LIMERICK GENERATING STATION UNITS 1 & 2
ENVIRONMENTAL REPORT - OPERATING LICENSE STAGE
REVISION 10 PAGE CHANGES

THIS EROL SET HAS BEEN UPDATED TO
INCLUDE REVISIONS THROUGH 10
DATED 02/83.

LIMERICK GENERATING STATION
UNITS 1 AND 2
ENVIRONMENTAL REPORT

FIGURE 5.6-1

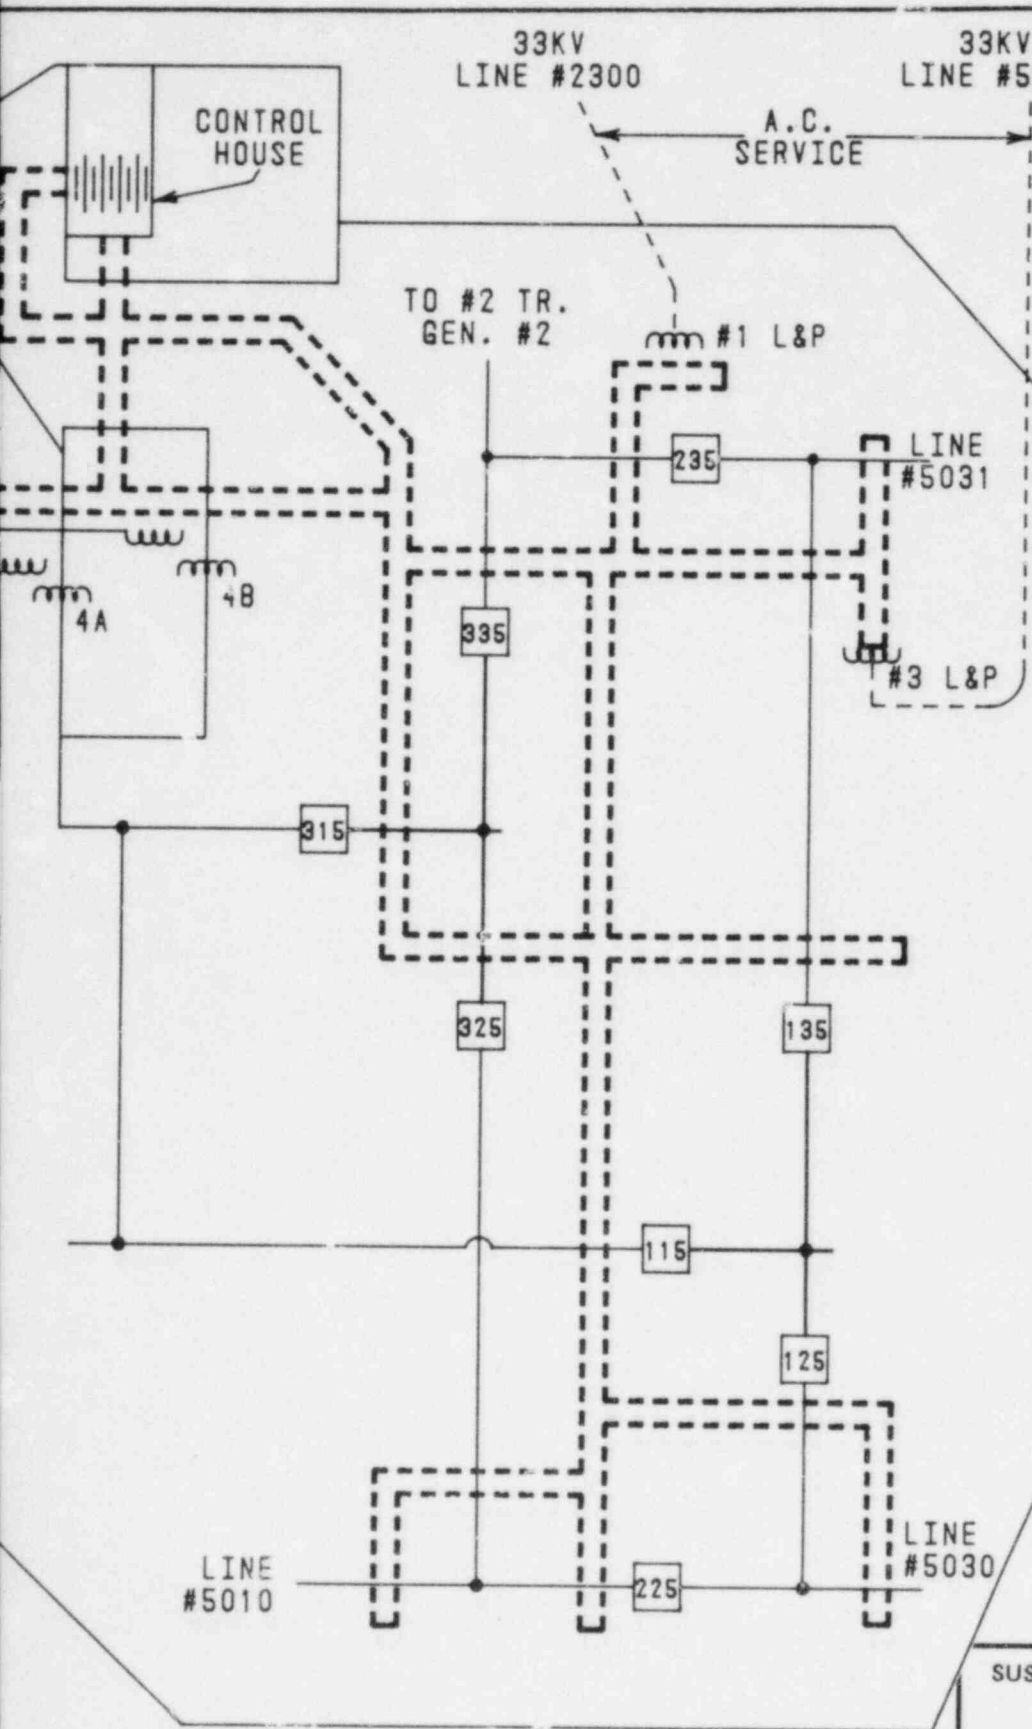
Provide location data for each of the transformers within the switchyards.

Figure 5.6-1 has been added to provide the requested information.

FIGURE E290.37-1

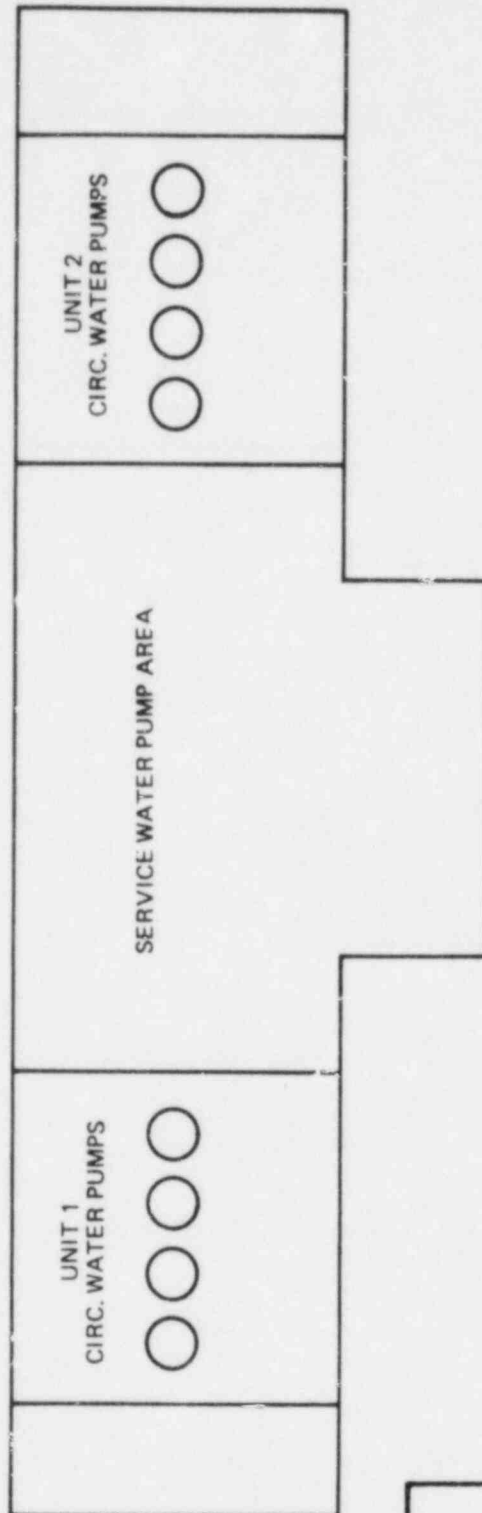
Provide information on flow rate, power rating, location and number of all circulating water pumps. Report pump location (i.e. direction and distance) from the cooling towers.

There are four circulating water pumps per unit. Each pump is capable of delivering 25 percent of the unit's requirements. The pumps are each rated for 113,000 gpm. The pumps are rated at 3450 hp and have 3500 hp motors.

Pumps are located within the circulating water pumphouse (Figure 2.1-4) as shown in Figure E290.37-1. Unit 1 circulating water pumps are southeast of the Unit 1 cooling tower at a distance of approximately 225 feet from the outer wall of the cooling tower basin. They are also approximately 37 feet below the cooling tower basin. Unit 2 circulating water pumps are in a corresponding location southwest of the Unit 2 cooling tower.

FIGURE E291.11-1

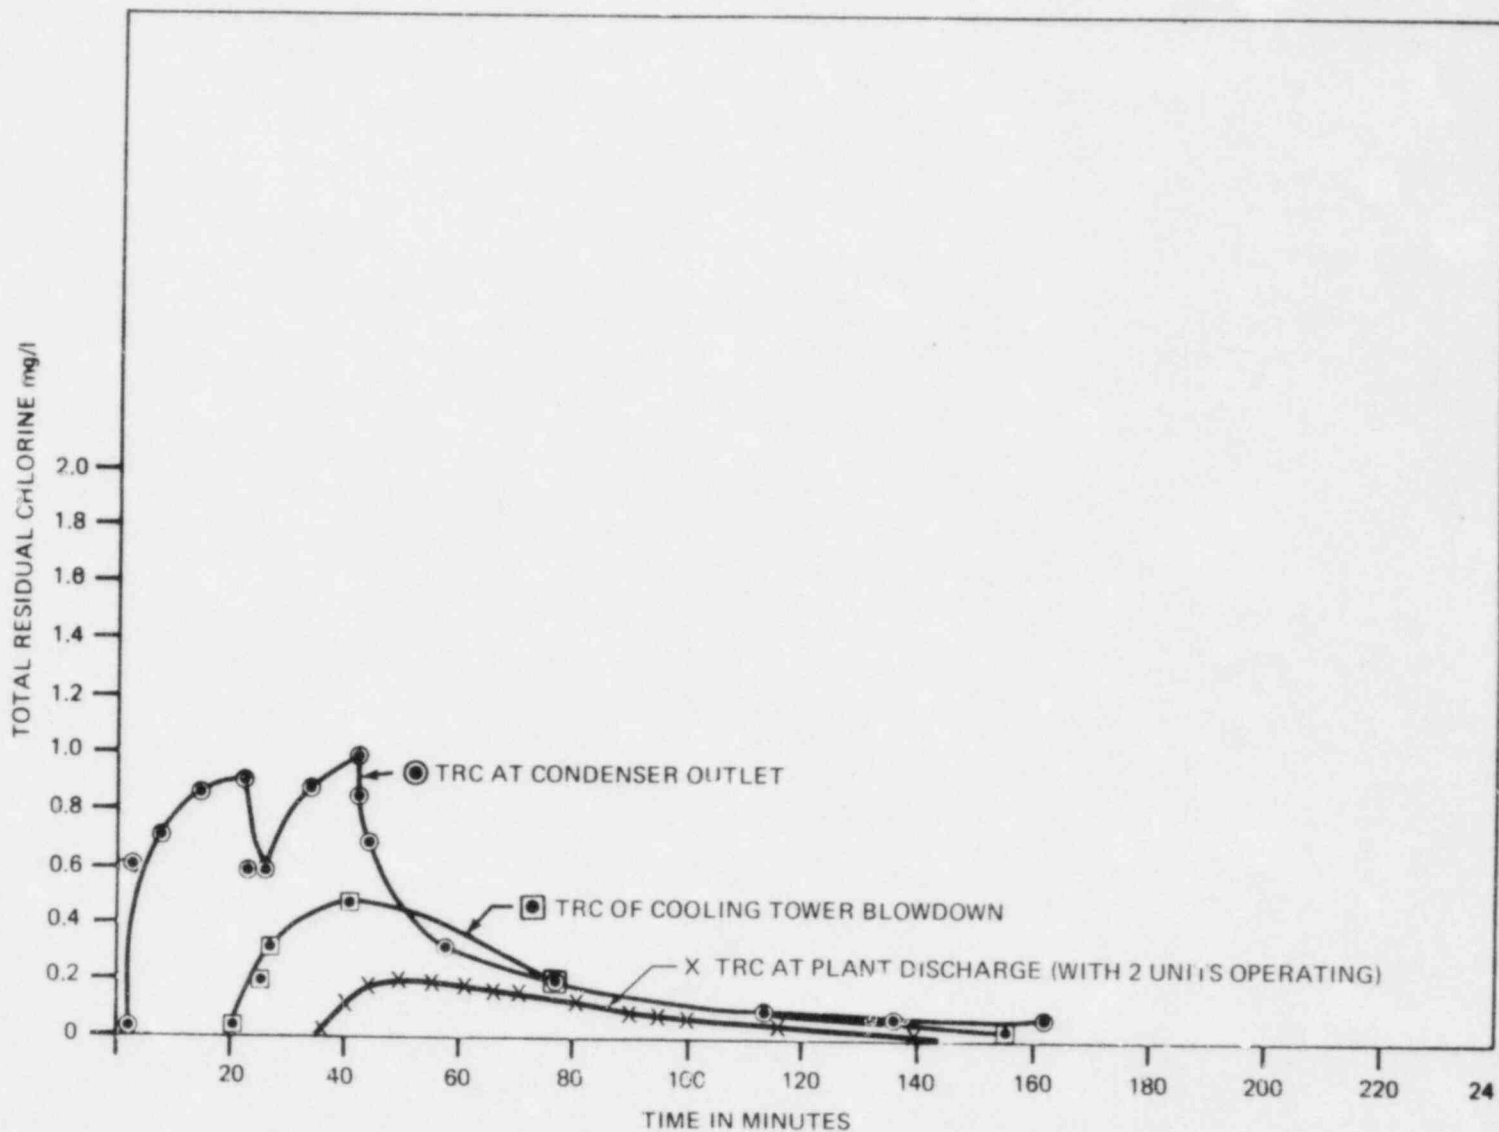
Provide a more accurate estimate of and bases for the estimate of condenser tube corrosion products in the station blowdown.

The maximum expected total residual chlorine (TRC) in the station discharge when two units (cooling towers) are operating is 0.22 mg/l (Figure E291.11-1). This takes into account the dilution effect of mixing with cooling tower blowdown from the second cooling tower. The chlorination of each tower is set 4 hours apart.

When cooling tower blowdown is available from the second cooling tower for dilution, the TRC in the station discharge will be greater than 0.1 mg/l for only 50 minutes (Figure E291.11-1). With one unit operating alone, the TRC in the station discharge will be greater than 0.1 mg/l for only 77 minutes (Figure E291.11-2).
